**Re: Partners Combined Substitute Water Supply Plan (WDID 0302556)
Treiber Lakes, DRMS Permit No. M-2011-049 (WDID 0303042)
Lamb Lakes portion of the Home Office Pit, DRMS Permit No. M-1977-439 (WDID 0303005)
Section 33, T8N and Section 3, T7N, R69W, 6th P.M.
Water Division 1, Water District 3, Larimer County
Plan IDs: 2998 and 5436**

Approval Period: January 1, 2018 through December 31, 2019

We have reviewed your letter dated November 9, 2017, requesting renewal of the above referenced substitute water supply plan ("SWSP") in accordance with § 37-90-137(11), C.R.S. This SWSP is requested to cover depletions for five previously mined gravel pits (ground water ponds) that are owned and operated by the Tri-Districts and the City of Greeley ("Partners" or "Applicant") and located within two permitted sites. The required fee of \$514 (2 × \$257) has been submitted (receipt nos. 3683565A-B).

HOME OFFICE PIT Pre-1981 Exposed Surface Area for 2011 Upper Poudre SWSP

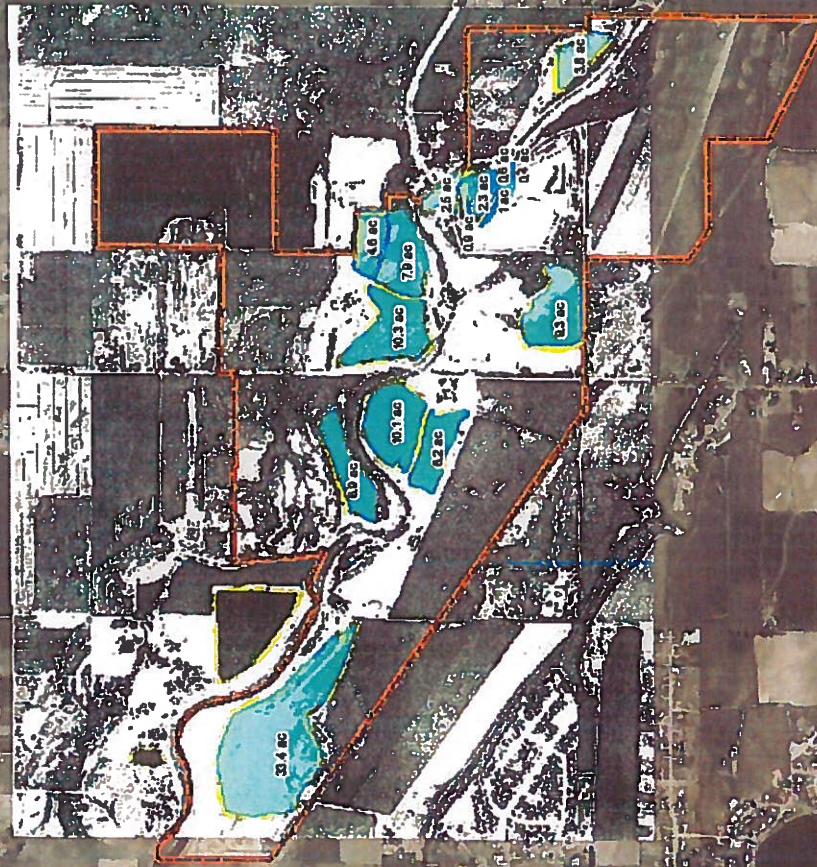
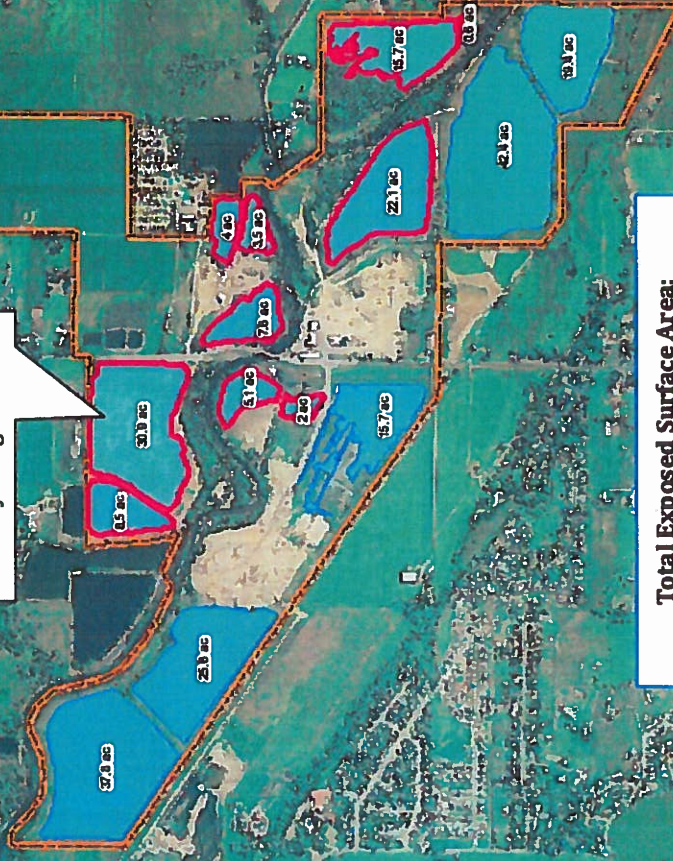
Pursuant to § 37-90-137(11)(b), C.R.S., and 2009CW49, a gravel pit operator or property owner does not need to replace depletions that occur due to evaporation from ground water exposed prior to January 1, 1981 as a result of open mining of sand and gravel ("pre-81 areas"), regardless of whether mining continued after December 31, 1980. Per our "General Guidelines for Substitute Water Supply Plans for Sand and Gravel Pits" updated April 1, 2011, pre-81 areas are tied to the physical location at which the groundwater was exposed prior to January 1, 1981 with the exception for areas whose reallocation was approved by the State Engineer prior to January 1, 2011. Previous SWSPs (prior to January 1, 2011) approved the pre-81 area without specific mention of its location. Therefore, the State Engineer's Office allowed the pre-81 area to be re-allocated and memorialized under the May 11, 2011 SWSP approval. The applicant provided a map (*Figure 1 - Home Office Pit*) showing the specific location of the pre-81 area, which includes the 22.1 acres of ground water exposed in Lamb Lake A. The credits for the pre-81 area are tied to the location identified on *Figure 1 - Home Office Pit* and may not be re-allocated to other areas of ground water exposure within the gravel pit boundary.

4. The total surface area of the groundwater exposed in the Lamb Lakes after December 31, 1980 must not exceed 61.8 acres, which results in an evaporative loss of 141.19 acre-feet per year. Should the total surface area exposed exceed this amount, an amendment will need to be filed with this office. The remaining lagged depletions at Treiber Lake B shall not exceed 0.07 acre-feet.
